Westinghouse
Electric Corporation

NTD-NRC-94-4249
DCP/NRC0173
Docket No.: STN-52-003

SUBJECT: WESTINGHOUSE RESPONSES TO NRC REQUESTS FOR ADDITIONAL
INFORMATION ON THE AP600

NTD-NRC-94-4249
ATTACHMENT A
AP600 RAI RESPONSES
SUBMITTED JULY 29 1994

Figure 3.7.3-1
Impact Evaluation Zone

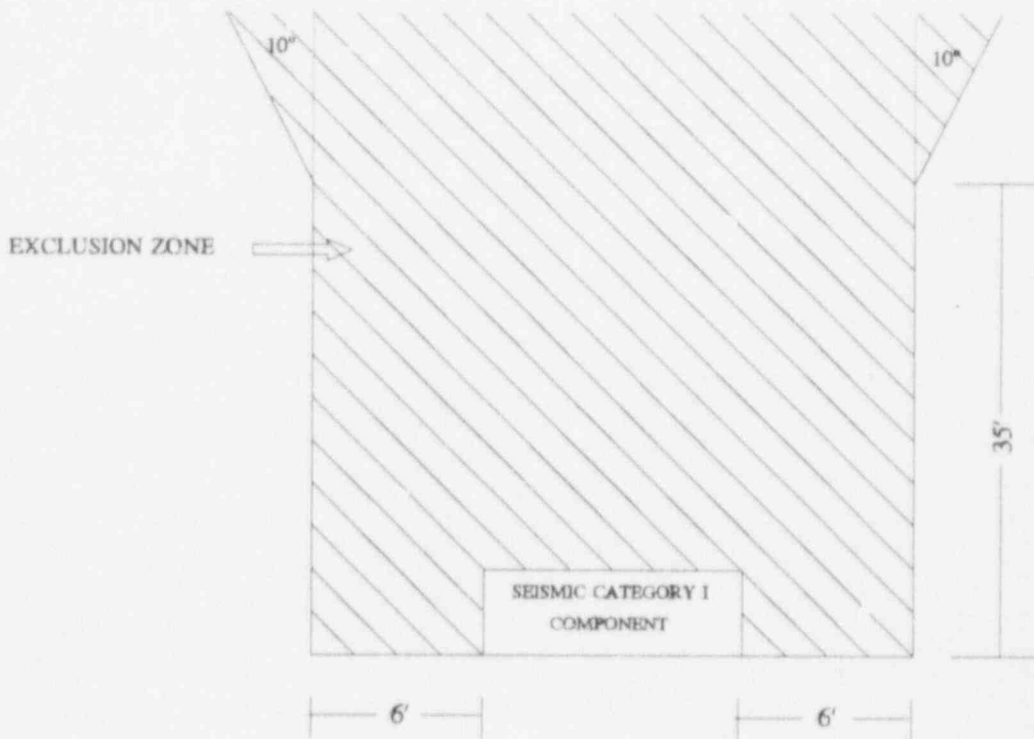
The criteria in Sections 3.7.2.8 and 3.7.3.13 of the SSAR, relative to protecting certain SSCs from adverse seismic interactions, are used for the design of the AP600. However, during the construction phase, interferences from field run items may lead to such interactions. To identify and correct such potentially adverse interactions, provide a statement in the SSAR that the COL applicant should describe the process for completion of the design of balance-of-plant and non-safety systems to minimize II/I interactions and propose procedures to be used for performing an assessment of the as-built plant to verify that the interaction of non-seismic SSCs with seismic SSCs does not affect the safety function of the seismic SSCs.

The criteria for protection against seismic interaction are defined in SSAR Subsection 3.7.3.13. The design will be pre-engineered and there will be few, if any, field run items. The criteria are also applicable to the process for completion of detailed design, including reconciliation of as-procured equipment. SSAR Subsection 3.7.3.13 is revised as shown below to include the confirmatory analyses performed by the Combined License applicant. Subsection 3.7.3.13.2 is revised to include the criteria to determine if a nonseismic source is located in a manner where its failure could result in impact on a safety-related item.

in the event the supports of the source were to fail and allow the source to fall. The impact evaluation zone is defined by the volume extending 6 ft horizontally from the perimeter of the Seismic Category I object up to a height of 35 ft. The impact evaluation zone above 35 ft is defined by a 10-degree cone radiating vertically from the foot of the object, projected from its perimeter. This definition of the impact evaluation zone is illustrated in Figure 3.7.3-1. The impact evaluation zone need not extend beyond seismic Category I structures such as walls or floor slabs.

Figure 2A-32
Effect of P Wave Damping

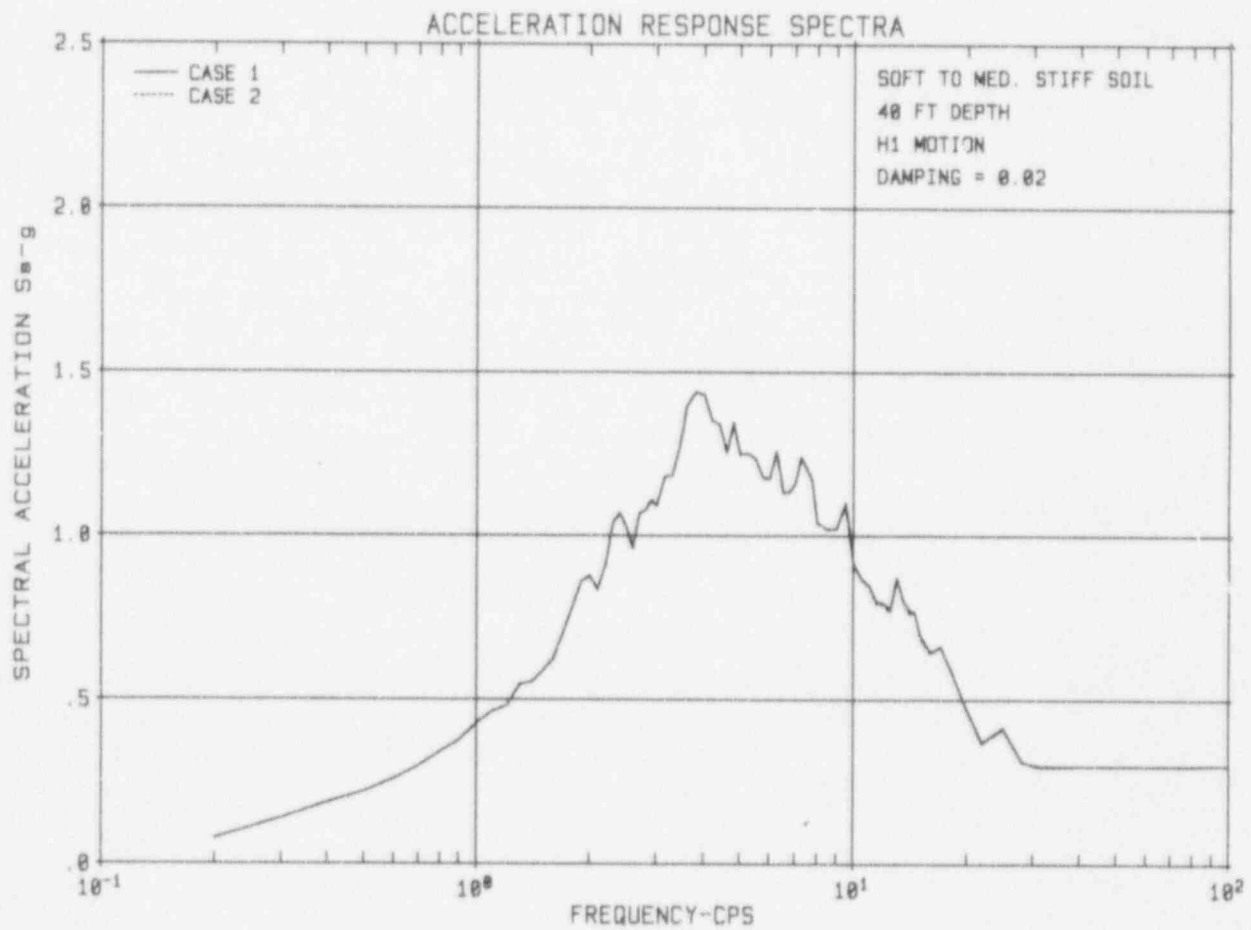
The soil column properties for horizontal and vertical (P-wave) models are not consistent. Specifically, (a) the damping ratio for S & P wave motions are different, and (b) Poisson's ratio for soils above the ground water table appear to be too high. Provide an explanation to justify (a) the use of same properties for the horizontal and vertical models, and (b) the use of a high Poisson's ratio in the analysis.

The strain-compatible soil/rock shear modulus and damping (for shear wave) were obtained from the average properties of two SHAKE analysis results of the respective soil/rock profile: using H1 and H2 time histories as described in Section 2A.4 of the SSAR. These properties shown in Tables 2A-9 through 2A-12 were subsequently used in the SSI analysis. Along with these properties, the P-wave velocity and the damping associated for P-wave were obtained and used in the SSI analyses. The SSAR revision identified below provides the requested explanation.

The above relationship is based on zero dissipation for volumetric changes. The values for β_s and V_p were obtained from Table 2A-10 and V_p was assumed to be 5,000 ft/sec. If β_p was found to be less than 0.1 percent, the minimum of 0.1 percent was used. The response spectra in the free field at the depth of 40 ft corresponding to the basemat elevation are compared in Figure 230.63-1. The results are almost identical such that the curves for the two cases are essentially superimposed. The results are not affected by the P-wave damping ratio. This is due to the fact that the soil column frequency at 40 ft depth is larger than 31 Hertz and the input motion at ground surface is effectively retained at the basemat level in the free field. For this reason, use of smaller P-wave damping values is not expected to affect SSI responses significantly.

This relationship is based on zero dissipation for volumetric changes. The values for β_s and V_s were obtained from Table 2A-10 and V_p was assumed to be 5,000 ft/sec. If β_p was found to be less than 0.1 percent, the minimum of 0.1 percent was used. The response spectra in the free-field at the depth of 40 ft corresponding to the basemat elevation are compared in Figure 2A-32. The results are almost identical such that the curves for the two cases are essentially superimposed. The results are not affected by the P-wave damping ratio. This is due to the fact that the soil column frequency at 40 ft depth is larger than 31 Hertz and the input motion at ground surface is effectively retained at the basemat level in the free-field. For this reason, use of smaller P-wave damping values is not expected to affect SSI responses significantly.

Figure 440.078-1

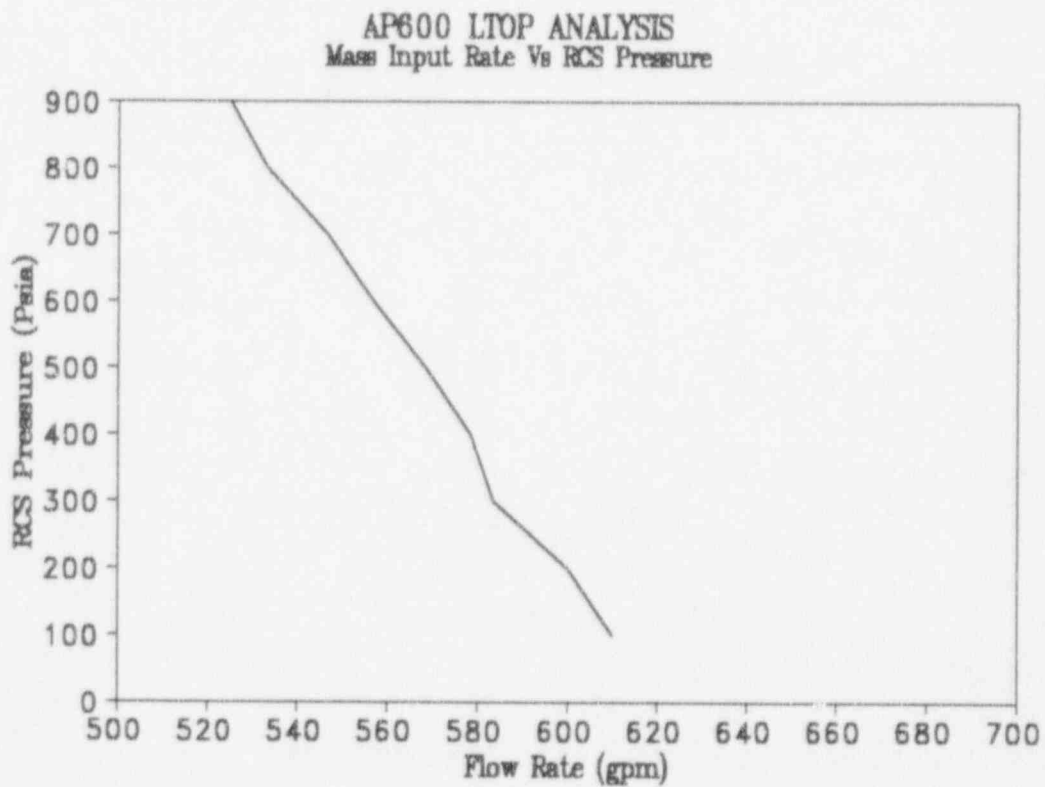
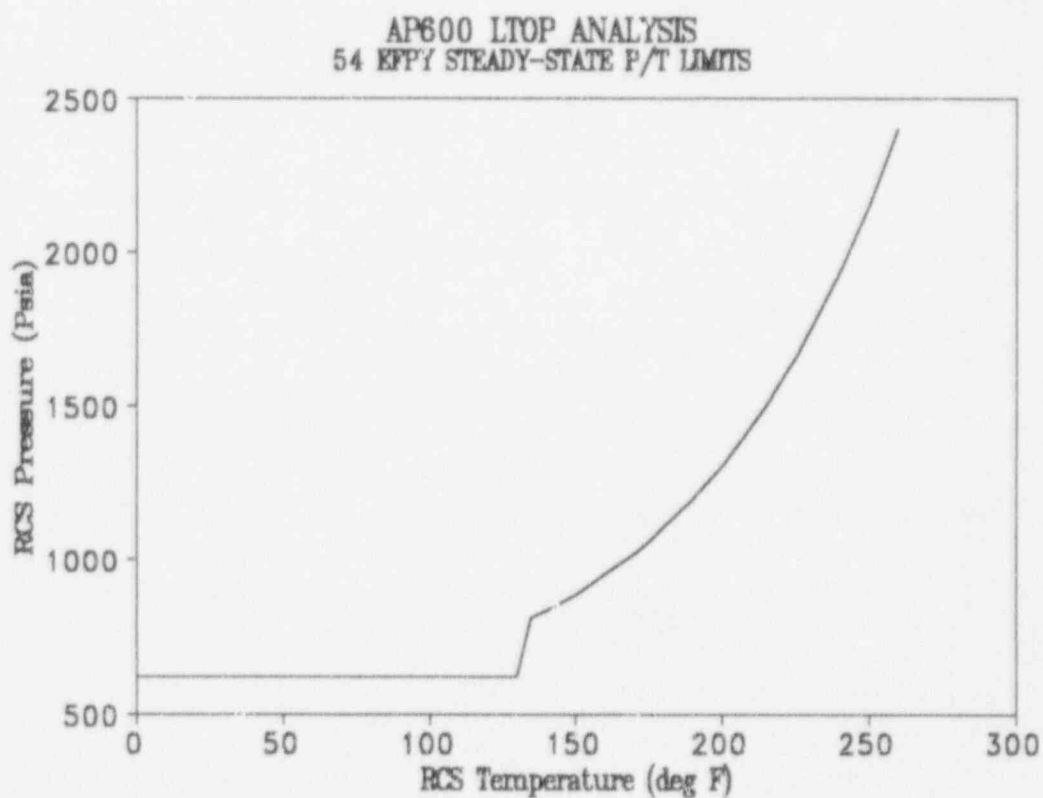
- a. Provide the safety analyses and results for both the mass and energy input overpressurizing design basis transients that demonstrate proper sizing of the NRHRS relief valve for LTOP. The results should include transient curves that demonstrate that the peak RCS pressures are within the design pressure-temperature (P/T) limits determined for the AP600.

- a. The normal residual heat removal system (RNS) relief valve, which mitigates the low temperature overpressure transients is sized to prevent the RCS pressure from exceeding the applicable pressure-temperature (P/T) limit. The limiting mass and energy input transients assumed for the sizing analysis are as follows:
 - Mass Input: Maximum makeup water flow to the RCS assuming both CVS makeup pumps are in operation and letdown is isolated. Figure 440.78-1 shows the mass flow rate assumed in the analysis. This transient is postulated to occur over a range of reactor coolant temperatures between 100°F and 350°F.
 - Energy Input: Restart of one reactor coolant pump with water in the steam generator secondary side 50°F hotter than the primary side water, and the RCS water-solid. This transient is postulated to occur over a range of reactor coolant temperatures between 100°F and 200°F.

The minimum RNS relief valve capacity has been calculated at an RCS pressure equivalent to the valve setpoint of 563 psig plus 10% accumulation (619 psig). With this setpoint, the relief valve would mitigate the limiting LTOP transient while maintaining the RCS pressure less than the P/T limit. The nominal steady-state P/T limits applicable up to 54 effective full power years (EFPY) as shown in Figure 440.78-2 is assumed in the analysis. Since the relief valve does not have a variable P/T lift setpoint, the setpoint plus 10% accumulation must be less than the bounding P/T limit. From Figure 2, the bounding P/T limit is 621 psig at the flange.

The results of the analysis show that the mass input transient is limiting up to 205°F. Since, the energy input transient is considered not credible above 200°F, the mass input transient is limiting for the entire range of the LTOP operation. With RCS in water-solid condition, the minimum RNS relief valve capacity required is 555 gpm which is the maximum makeup water flow at 619 psig RCS pressure.

A transient curve that illustrates that the peak RCS pressures are within the design P/T limits has not been generated in the analysis since the transient response is a constant RCS pressure at 619 psig for all RCS temperatures less than 350°F.
